Case Number: R18027

CASE COMMENTS:

Prior to Final DRC sign-off, please provide updated plans and written response to the following review comments:

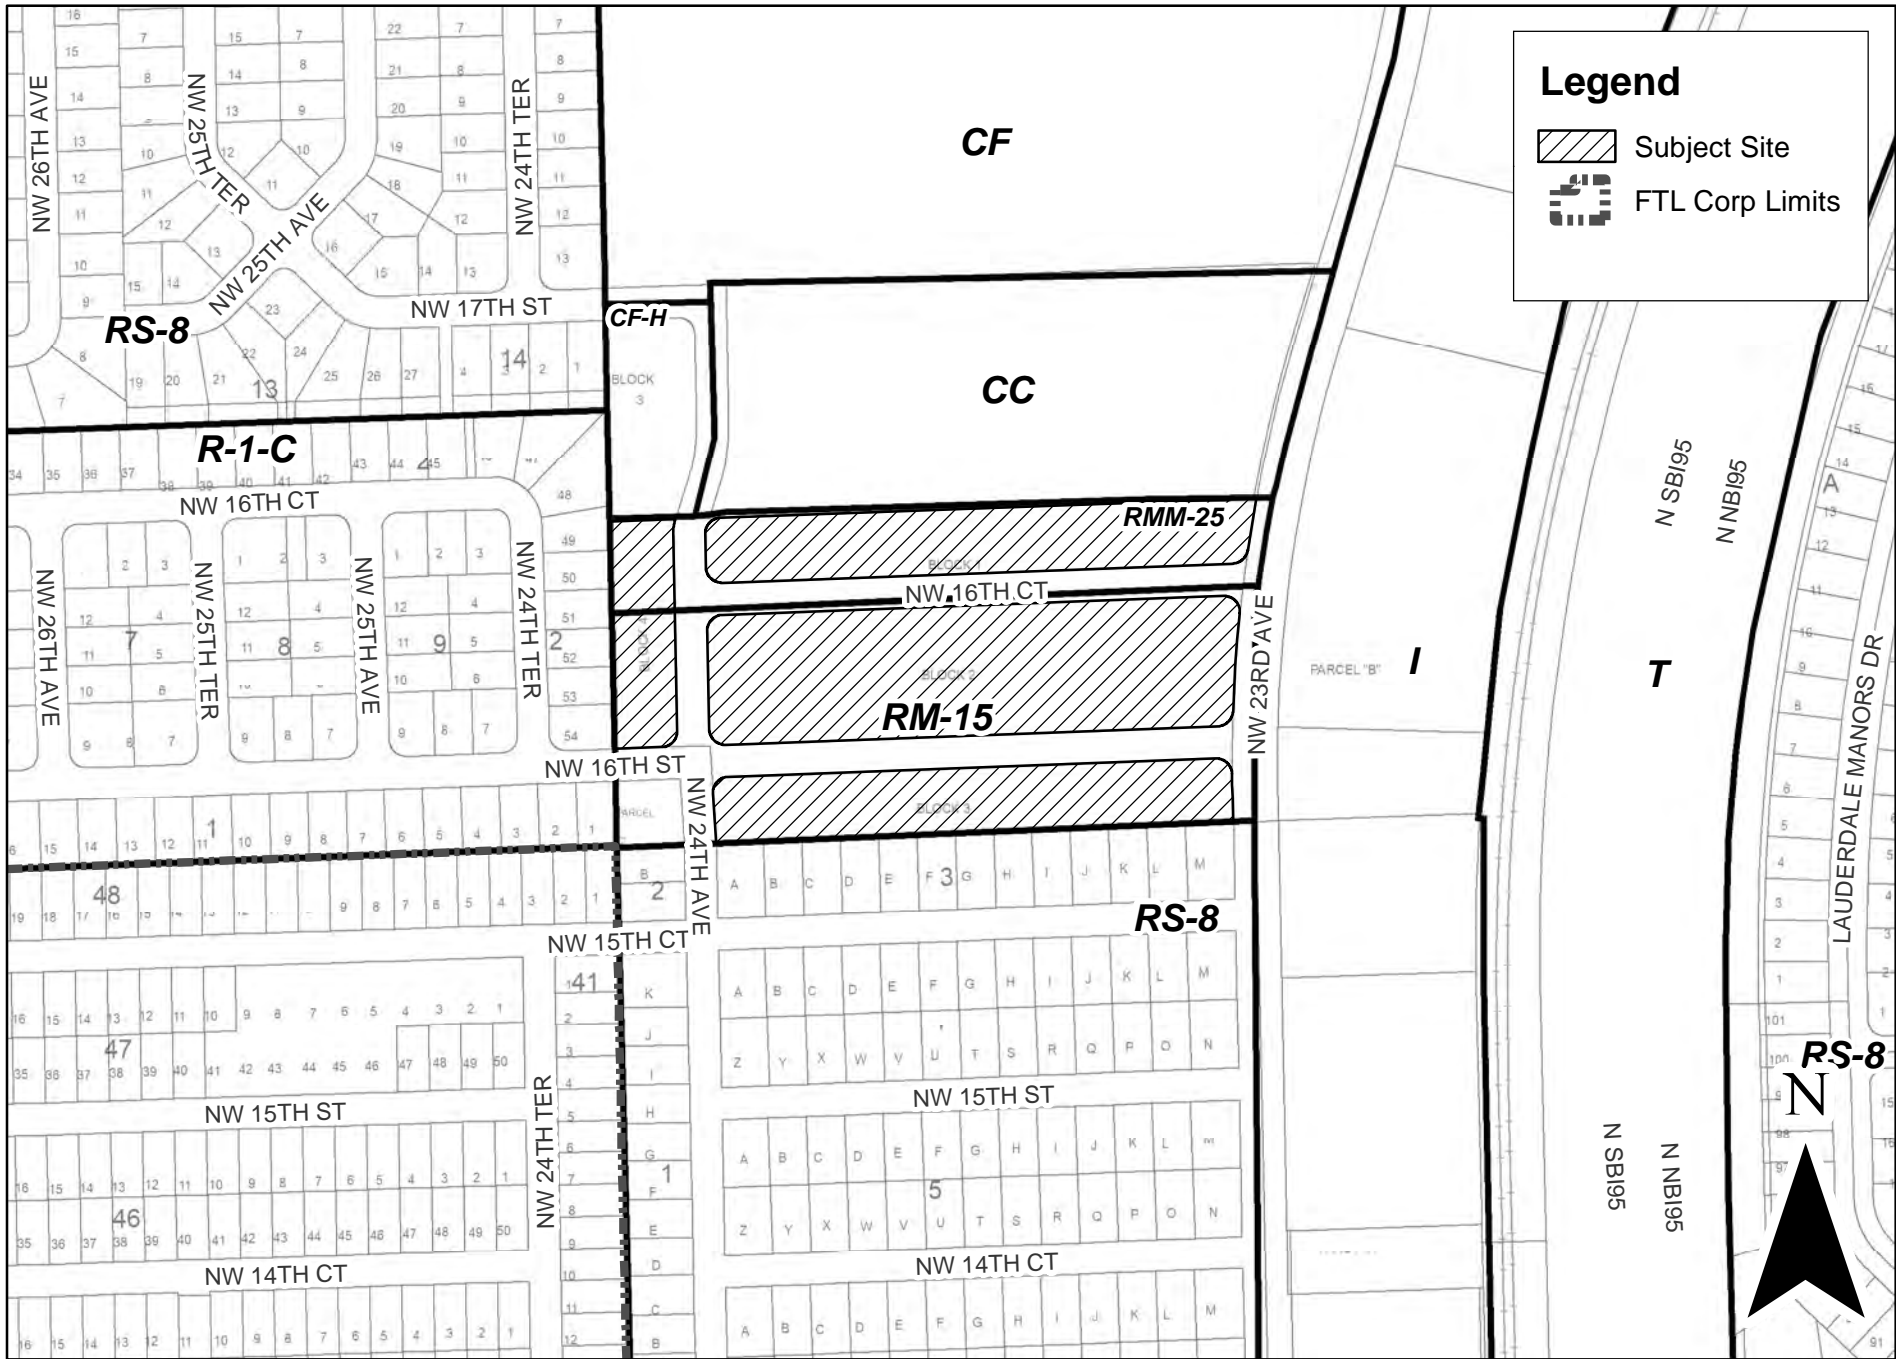
- 5) Provide the zoning designation lines on the Overall Site Plan sheet.
- 6) Provide the following changes on site plan:
 - a) Provide a new 5' wide sidewalk and it should be separated from the right-of-way along NW 23rd Avenue with adequate landscaping. Please coordinate with the Landscape Plan Reviewer, Kim Pearson. This will create a safe, comfortable pedestrian environment along the ROW.
